Service Bulletin

14-070

Safety Recall: Front Passenger's Airbag Inflator May Produce Excessive Pressure After Long-Term Exposure To High Absolute Humidity

Supersedes 14-070, dated June 16, 2015; see Revision Summary

Part Number

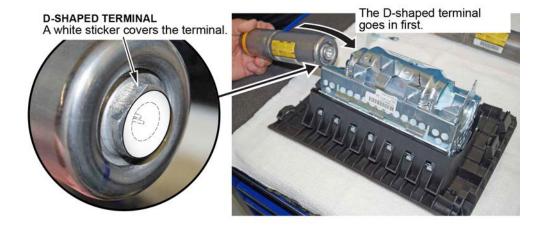
Check your part number against the ones listed for each installation procedure. Use the correct installation procedure for the part you received.

• One connector looks like a "D" whereas the other connector is a circle. Make sure you insert the "D" shaped terminal into the airbag first.

NOTE: There is a yellow band marking on the circle side.

• Slide the inflator in until the "D" aligns with the tab on the inflator bracket. There should be no space or gap between the inflator and bracket.

• Reinstall the inflator bracket. There should be no space or gap between the bracket and inflator.

Part Number

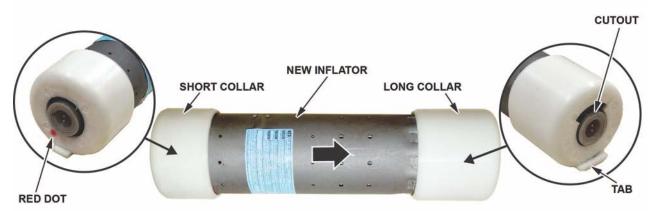
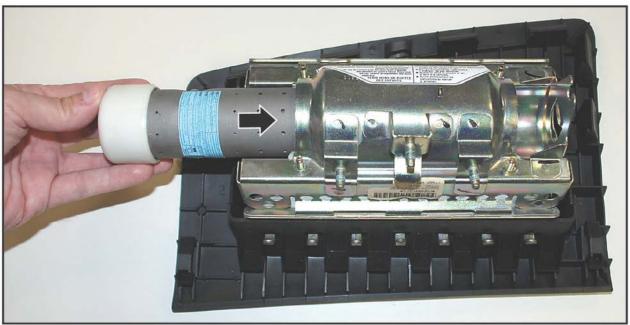
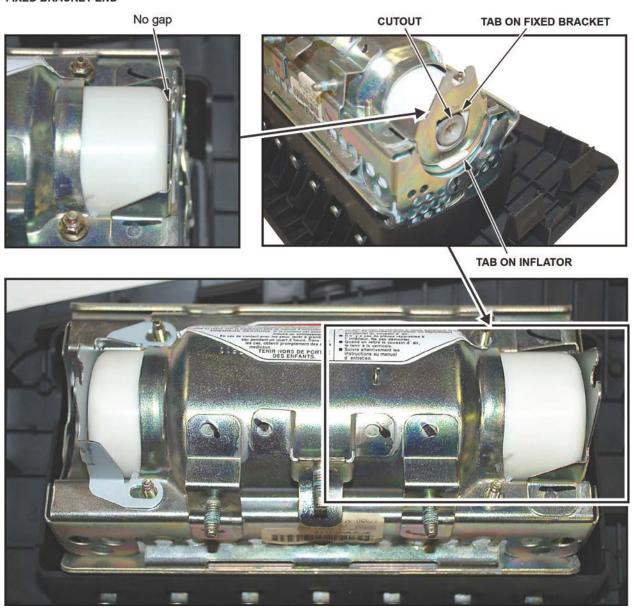
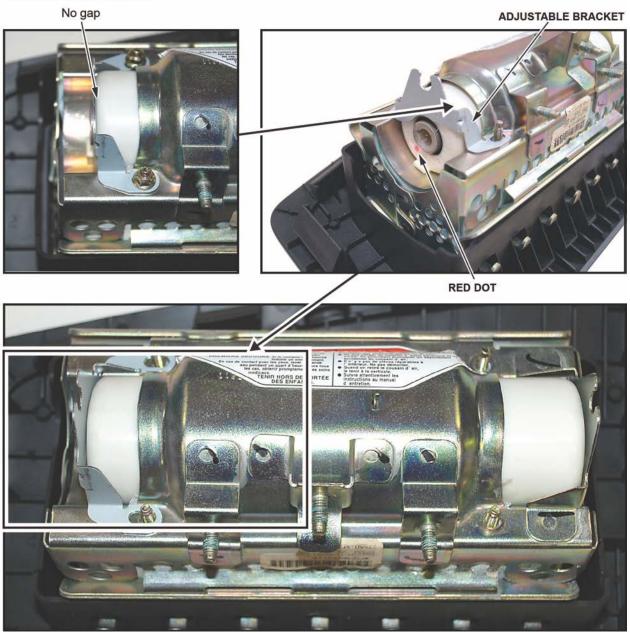
Check your part number against the ones listed for each installation procedure. Use the correct installation procedure for the part you received.

• One side of the inflator has a longer collar, a longer tab, a plastic cutout, and a small flat spot on the connector. The other side of the inflator has a shorter collar, a shorter tab, and a red dot. Make sure you insert the end with the longer collar into the airbag first.

Slide the inflator in until the plastic cutout and the small flat spot align with the tab on the bracket. There should be no space or gap between the inflator and bracket.

• Install the bracket included in the kit onto the airbag module. There should be a red dot visible on the end of the plastic connector. There should be no space or gap between the inflator and bracket.

04790-S9A-305 04790-S0X-305 04790-S9V-305

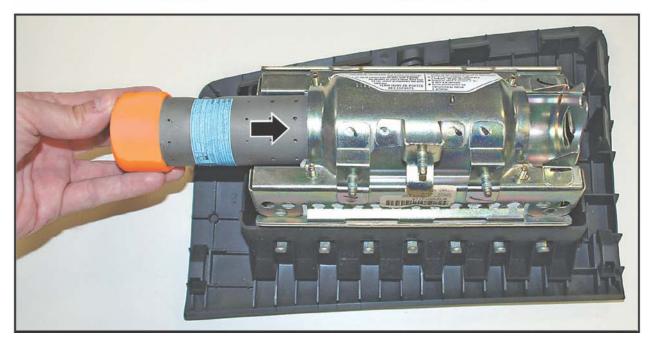
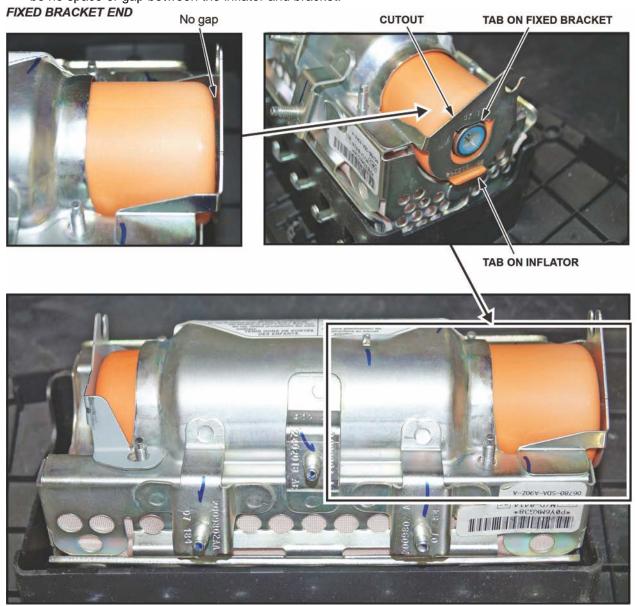
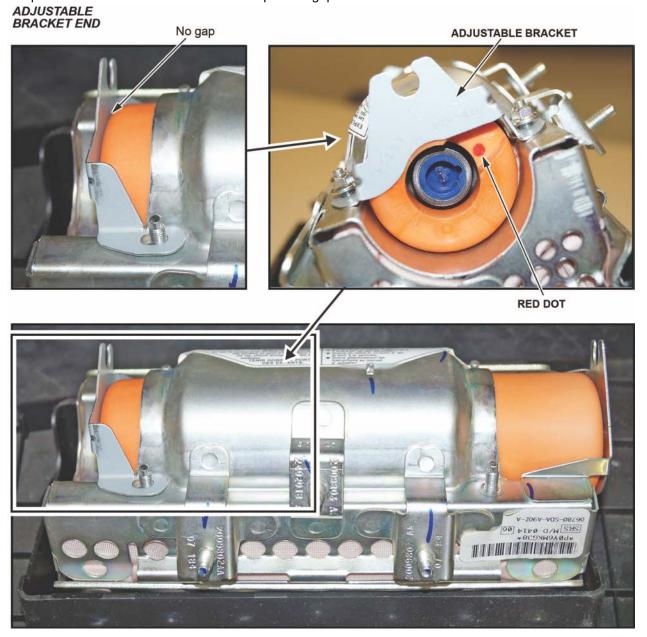
Check your part number against the ones listed for each installation procedure. Use the correct installation procedure for the part you received.

• The collars on this inflator are orange, not white. One side of the inflator has a longer collar, a tab, a plastic cutout, and a small flat spot on the connector. The other side of the inflator has a shorter collar, no tab, and a red dot. Make sure you insert the end with the longer collar into the airbag first.

• Slide the inflator in until the plastic cutout and the small flat spot align with the tab on the bracket. There should be no space or gap between the inflator and bracket.

• Install the bracket included in the kit onto the airbag module. There should be a red dot visible on the end of the plastic connector. There should be no space or gap between the inflator and bracket.
